AIRWORTHINESS DIRECTIVE GLIDERS/POWERED SAILPLANES

GFA/AD 238

SCHEMPH-HIRTH 15

Prevention of elevator and rudder flutter.

Cover plate for locking the tail parachute operating handle

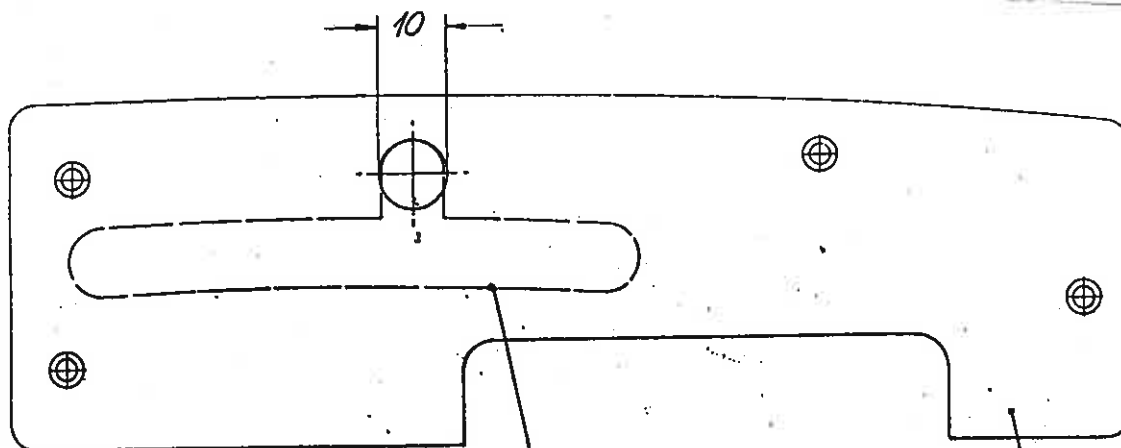
- a) Lock the operating handle for the tail chute in the cockpit as shown on the sketch, page 4 of this note.
- b) Screw off the blue ball knob.
- c) Remove the reference placard for tail chute operation, if any.

The guide slot for operating the tail chute handle must be omitted

Use the already installed cover plate as a pattern

Material:

Aluminum alloy half-hard - hard AlMg1
sheet 1.5 mm thick

Techn. Note No. 265-6
Elevator mass balance
zu TM-Nr. 265-6

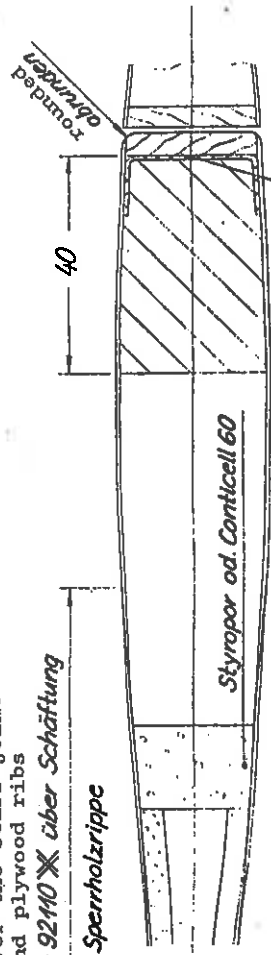
If the values of hinge moments and weights on page 27 of the Service Manual (see Action 5) are exceeded, a mass balance must be installed outboard on the elevator in accordance with the drawing.
Cirrus No. 30.001/1 - Elevator mass balance.

200 g grain of
lead mixed with
resin
Bleischrot 200g
mit Kunstharz

With lead weight installed
on the elevator, the
force at the trailing
edge at the root rib should
be between 125 g
and 160 g.

Elevator drive axle

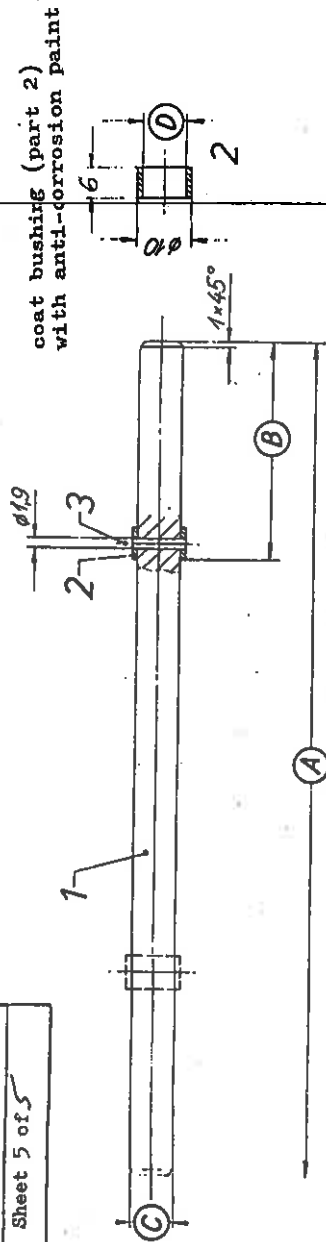
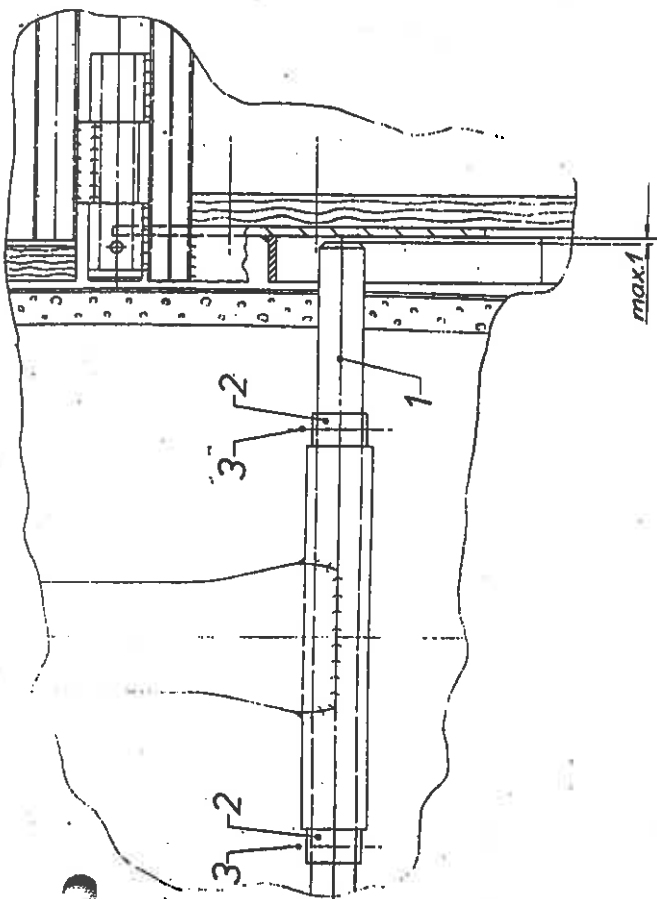
If not previously modified, the drive tube (dia 8mm) on the elevator drive lever must be replaced by a round bar in accordance with the drawing Cirrus No. 30.011/1 - Elevator drive axle.

coat bushing (part 2)
with anti-corrosion paint

Measures (A), (B)

are to be taken from the originally installed tubular drive axle.

Care is to be taken that the distance between the drive axle (part 1) and the drive fitting on the elevator root rib is not greater than 1 mm.

The outer diameter of the elevator drive axle (part 1) and the inner diameter of the bushing (part 2) is determined by the following requirements:

1. Small internal play in the tube of the drive lever on the fin.
2. Small play in the elevator drive fittings (max. permissible play in the elevators against one another:
3 mm, measured at the trailing edge of the root ribs.

The drive axle (part 1) should be well greased before inserting it into the tube of the elevator drive lever.
